ITEM	SECTION	SUMMARY	PROPONENT	ACTION
IRC-2024-01	PREFACE Part IV Chapter 11	Part IV, Energy Conservation (Chapter 11) is deleted from the INTERNATIONAL RESIDENTIAL CODE FOR ONE- AND TWO-FAMILY DWELLINGS. Substitute all references to Chapter 11 ENERGY EFFICIENCY with references to the <i>Georgia State Minimum Standard Energy Code (International Energy Conservation Code with Georgia State Supplements and Amendments)</i> .	2020 amendments	CF
IRC-2024-02	PREFACE Part VII	Part VII, Plumbing (Chapters 25 through 33), is deleted from the INTERNATIONAL RESIDENTIAL CODE FOR ONE- AND TWO-FAMILY DWELLINGS. Substitute for plumbing requirements the <i>Georgia State Minimum Standard Plumbing Code (International Plumbing Code with Georgia State Amendments)</i> .	2020 amendments	CF
IRC-2024-03	PREFACE Part VIII	Part VIII, Electrical (Chapters 34 through 43) is deleted from the INTERNATIONAL RESIDENTIAL CODE FOR ONE- AND TWO-FAMILY DWELLINGS. Substitute for electrical requirements the <i>Georgia State Minimum Standard Electrical Code (National Electrical Code with Georgia State Amendments)</i> .	2020 amendments	CF

\*Note: These amendments are “proposed only” and have not been adopted by the Depar

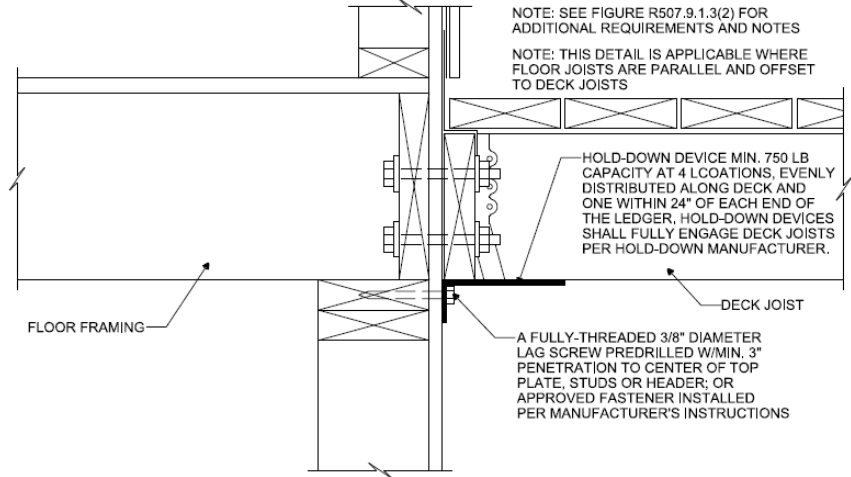
ITEM	SECTION	SUMMARY	PROPONENT	ACTION
IRC-2024-31	R507.9.1.3	<p>Revise section R507.9.1.3 ‘Ledger to band joist details’ to read as follows.</p> <p><b>R507.9.1.3 Ledger to band joist details.</b> Where ledgers are fastened in accordance with Table R507.9.1.3(1), fasteners shall comply with Section R507.2.3 <u>or other approved fasteners</u> and shall be installed in accordance with Table R507.9.1.3(2) and Figures R507.9.1.3(1) and R507.9.1.3(2). Holes for 1/2-inch (12.7 mm) lag screws shall be predrilled with two drill bits so that a hole 1/2 inch (12.7mm) in diameter is drilled through the ledger and sheathing, if present, and a hole 5/16 inch (7.9 mm) to 3/8 inch (9.5mm) in diameter is drilled through the band joist.</p>	2020 amendments	R
IRC-2024-32	R507.9.1.3 (2)	<p>Revise Figure R507.9.1.3(2) ‘Placement of Lag Screws and Bolts in Band Joists’ as follows:</p>  <p>(WITH CLADDING)</p>	2020 amendments	CF
